**RENEWABLE ENERGY APPROVAL  
MODIFICATION REPORT  
SOUTH BRANCH WIND FARM  
SOUTH DUNDAS WINDFARM LP**

**APRIL 2013**

**Project No. 121-22956-00**

## **2. SUMMARY OF PROPOSED MODIFICATIONS**

**Attachment A**  
**Original Layout in REA**

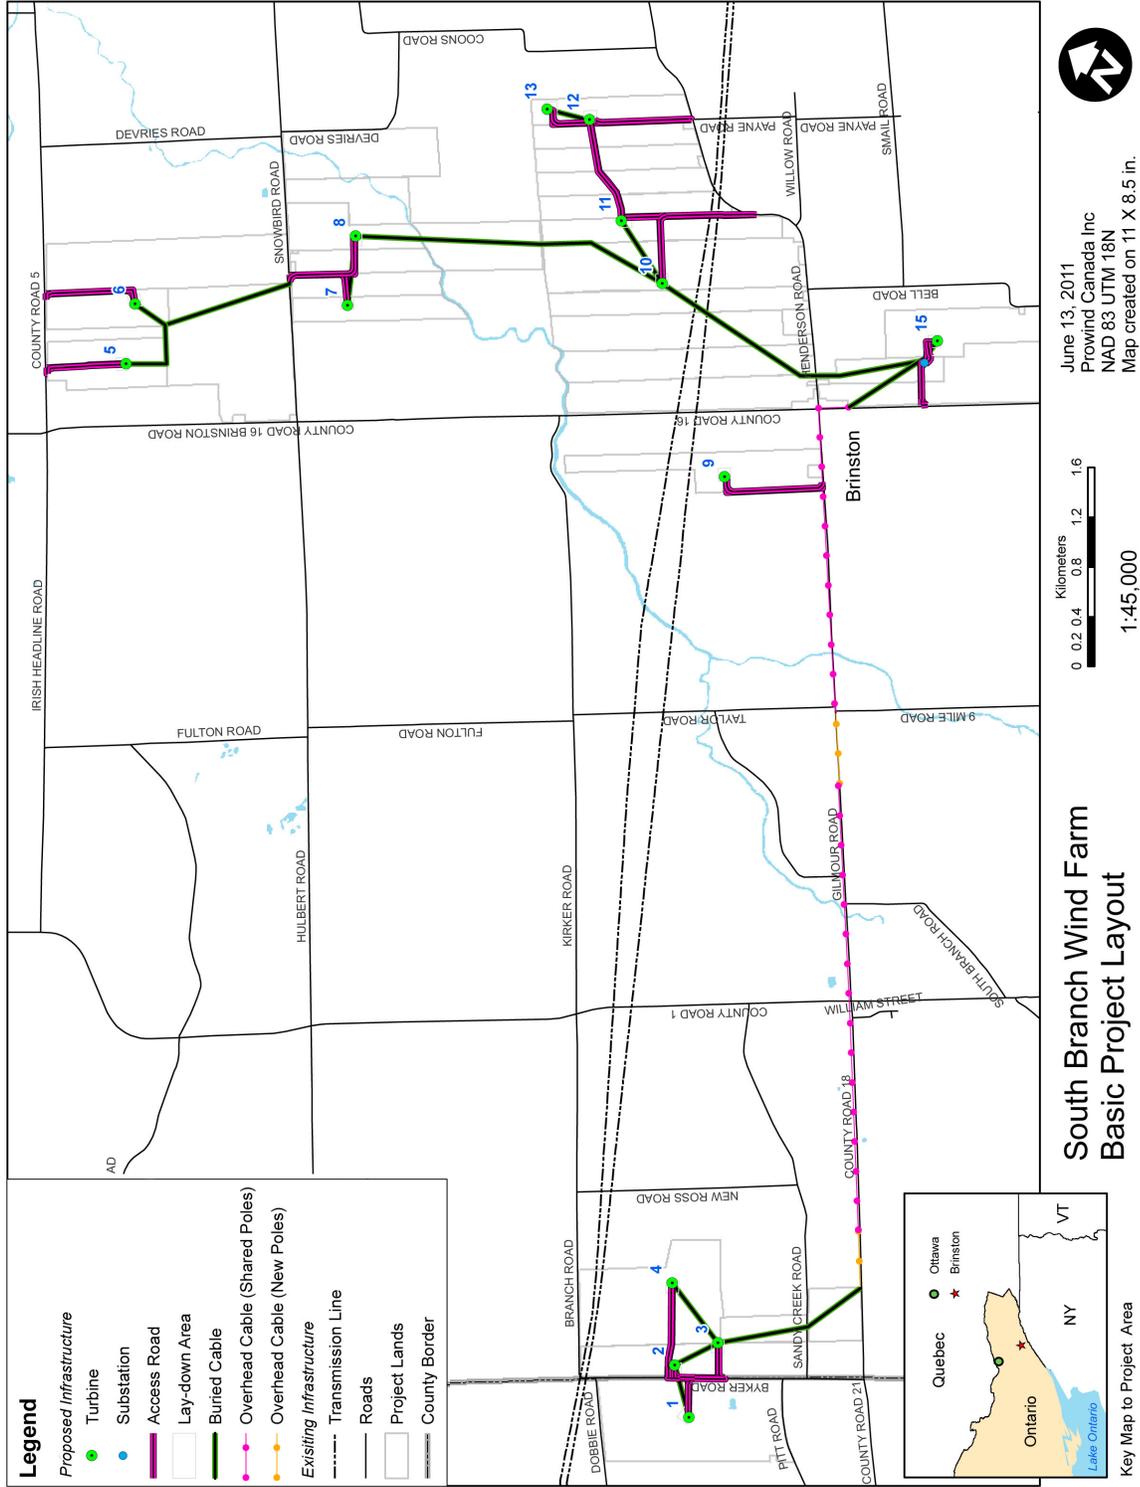
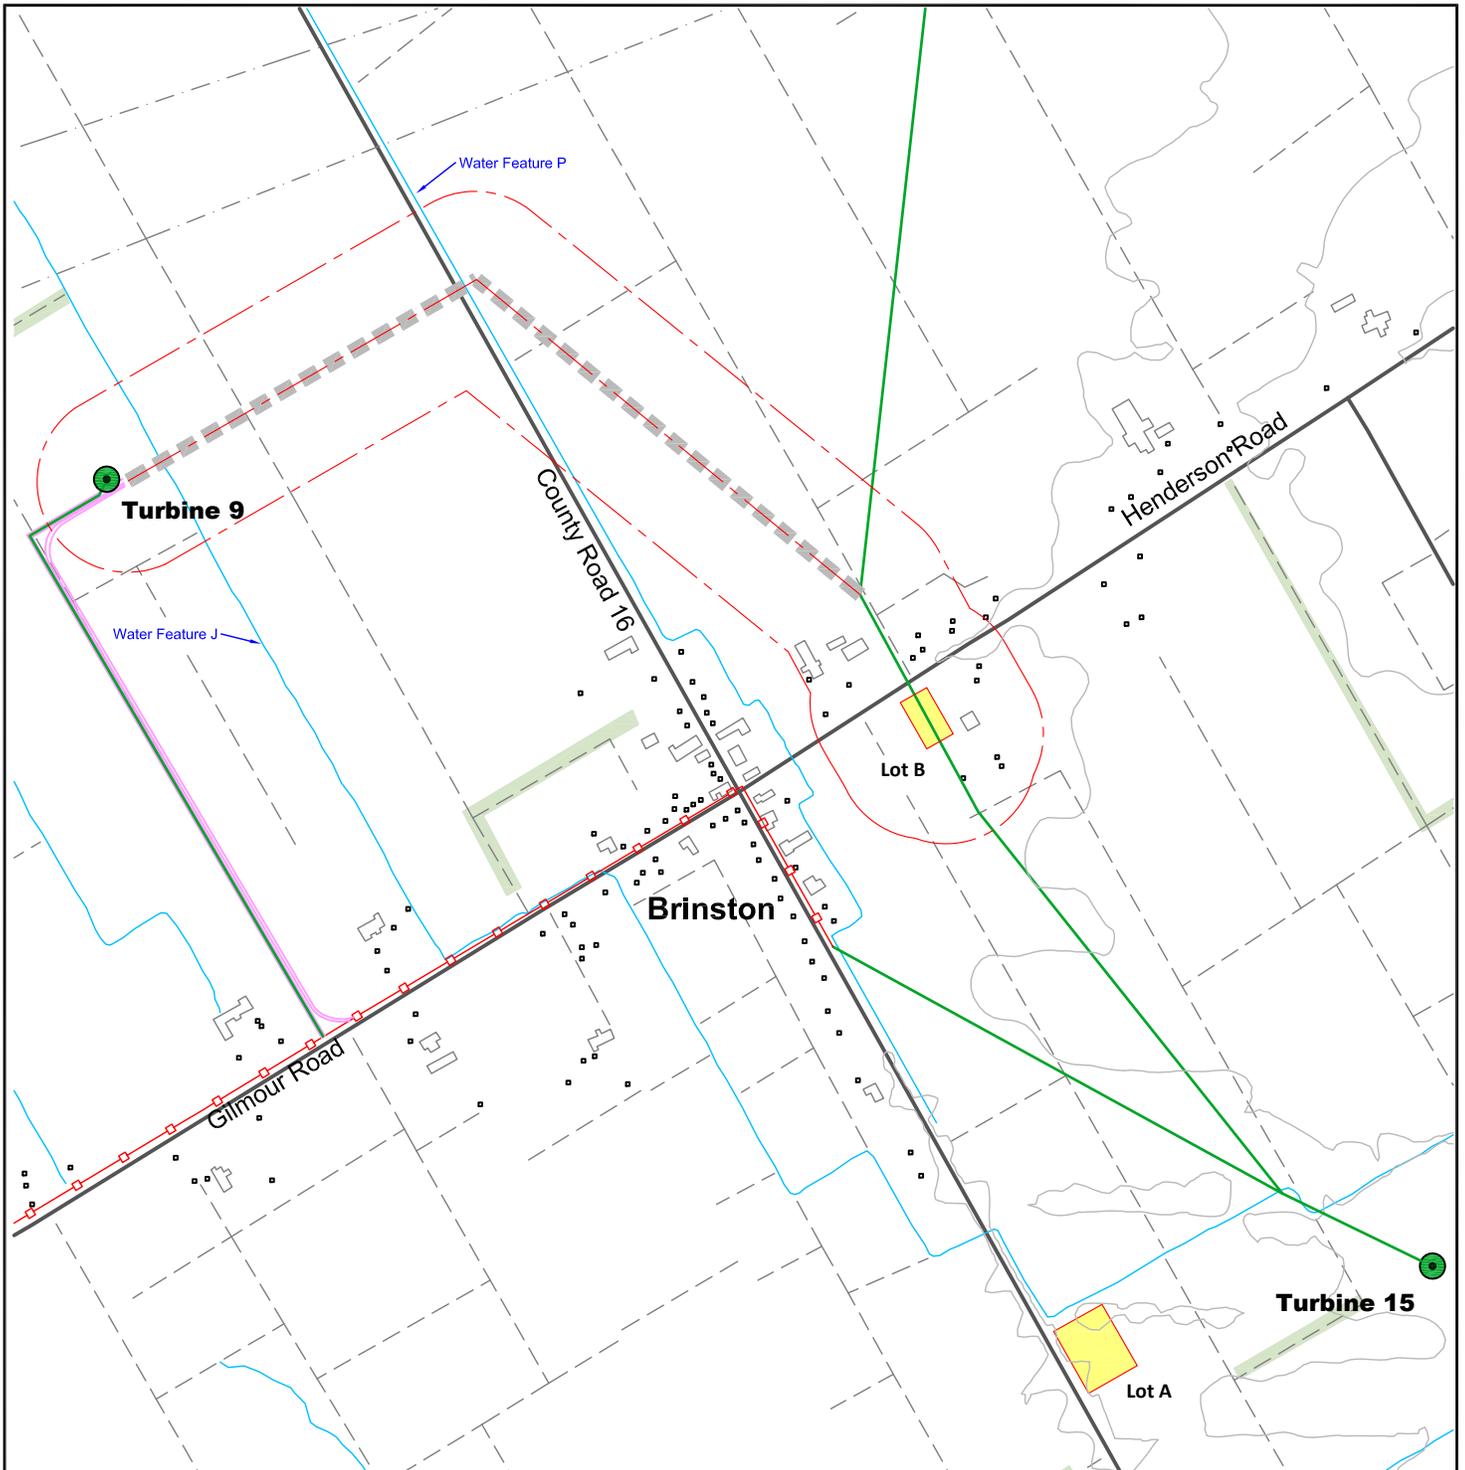
The area of change would be limited to the Township of South Dundas. Based on the site plan presented in the original REA documentation, the collection line for Turbine 9 (Attachment A) was proposed to travel underground west-southwest for 0.12 kilometers, turning south-southeast and travelling 0.75 kilometers to Gilmour Road, then surfacing and travelling overhead northeast for 0.65 kilometers within the road-right-of-way through the community of Brinston, then south-southeast along Brinston Road for 0.25 kilometers, finally boring underground and travelling southeast for 0.7 kilometers to the inter-connection point. The total length of collection line under the original REA proposal was 2.47 kilometers.

The area of change would be limited to the Township of South Dundas. Based on the site plan presented in the original REA documentation, the collection line for Turbine 10 (Attachment A) was proposed to travel underground north for 0.7 kilometers, turning northwest to Turbine 8. The total length of collection line based on the original REA proposal was 1.9 kilometers.

# SITE PLAN (LOCATION 1)

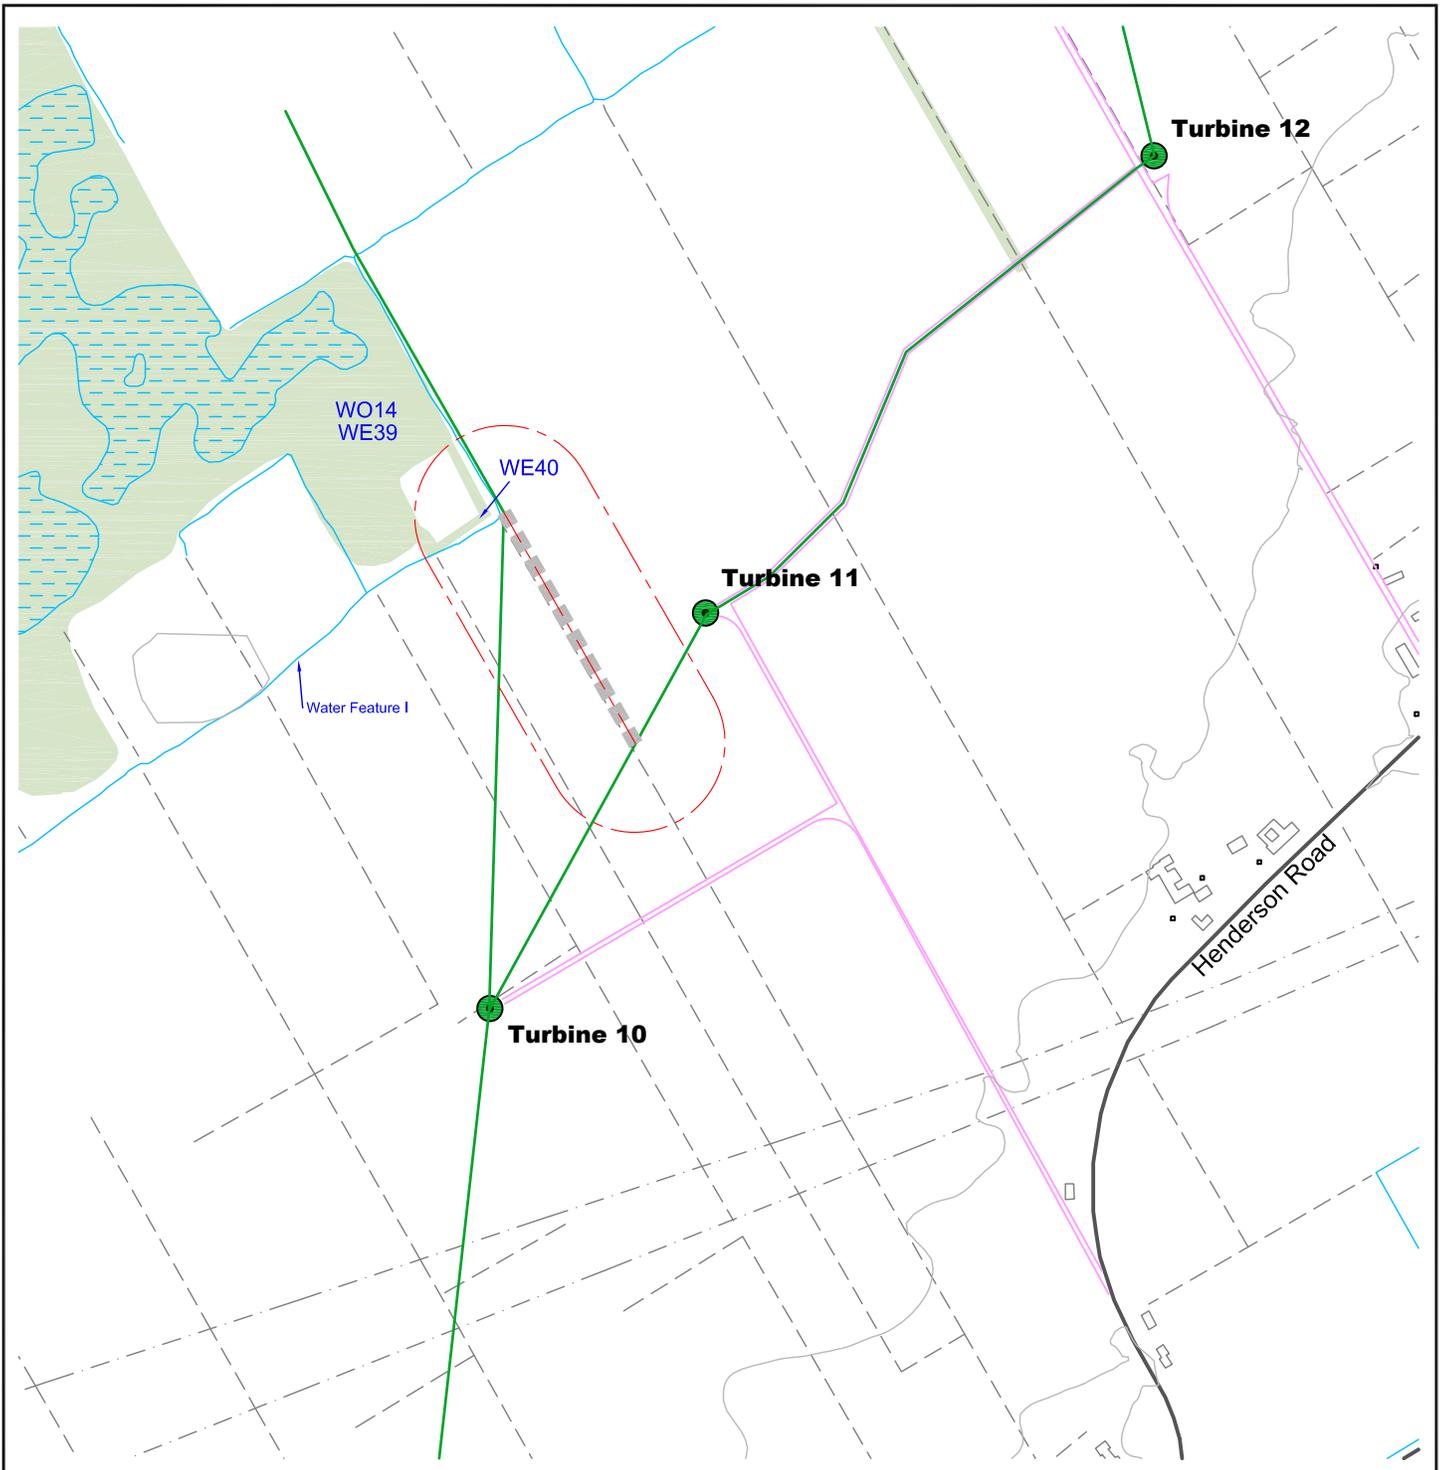
Under the modified collection route (Attachment B), the cable would travel underground only, going east-northeast from Turbine 9 for 0.55 kilometers, tunneling under County Road 16 to the adjacent property line and then travelling southeast for 0.65 kilometers to the original proposed underground collection line extending between Turbines 10 and 15. The total length of collection line under the contemplated revision would be 1.2 kilometers (roughly half the length of the original REA proposal) and would be entirely underground.

The modified collection route would be located entirely on private land. Previously, one section of land was not part of the project location since there was no infrastructure proposed on it. This section of land has now become part of the project location. Separate from the REA process, EDPR will obtain any permits needed from the County for collection line boring under County Road 16.

Under the modified collection route (Attachment B), the underground cable would travel to Turbine 11 as originally proposed, but would then travel northwest to Turbine 8, halfway between the originally proposed route between Turbines 10 and 11. This revision would result in reduced temporary impacts to hay fields, which have been identified by the MNR as potential bobolink breeding habitat. The total length of collection line under the contemplated revision would be 1.5 kilometers, reducing total collection line length by 0.4 kilometers. The cable is still proposed to be completely underground.

The REA application identified three potential locations for the O&M building, with the option to utilize any of the three sites. Based on additional work undertaken by EDPR it can now be confirmed that the preferred location is the property located south of Henderson Road and east of County Road 16. The property is large and there are two potential lots that could be used for siting the O&M building (refer to Attachment B).

Lot A is located along the east side of County Road 16, approximately 0.8 miles south of the intersection with Henderson Road. Lot A was previously assessed for archaeological and biological resources as part

Lot B is on the south side of Henderson Road approximately 0.3 km from the intersection with County Road 16. Lot B was not previously assessed for archaeological and natural heritage features. However, these assessments have been completed as part of this Modification Report. The determination of the exact footprint of the O&M building within one of the two specified lots will be based on input from the landowner and discussions with the municipality.
